Amendments to the Drawings:

Appl. No. 10/671,278
Amdt. dated September 2, 2005
Reply to Office Action of June 2, 2005

FIG. 7

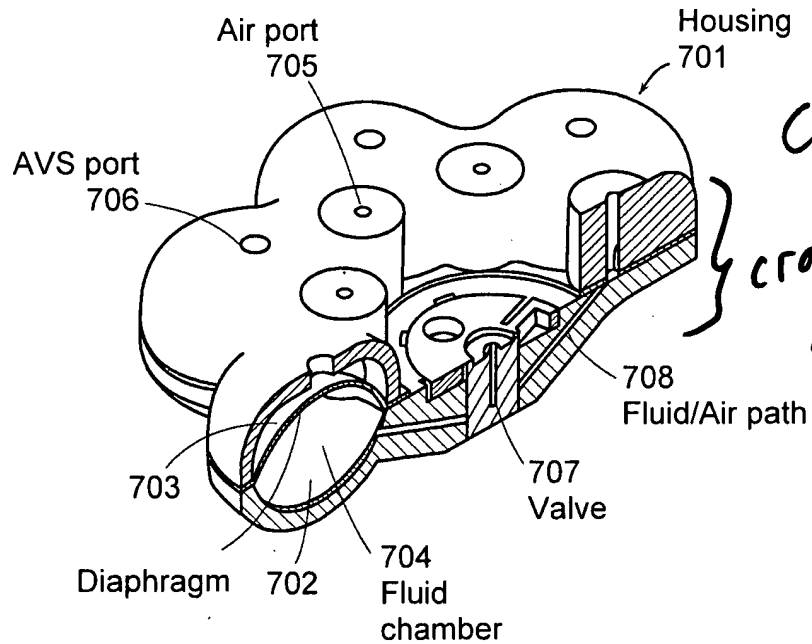
The attached sheet of drawings includes changes to Fig. 7. The attached sheet replaces the original sheet that included Fig. 7. In Fig. 7, cross-hatching has been provided to show a cross section.
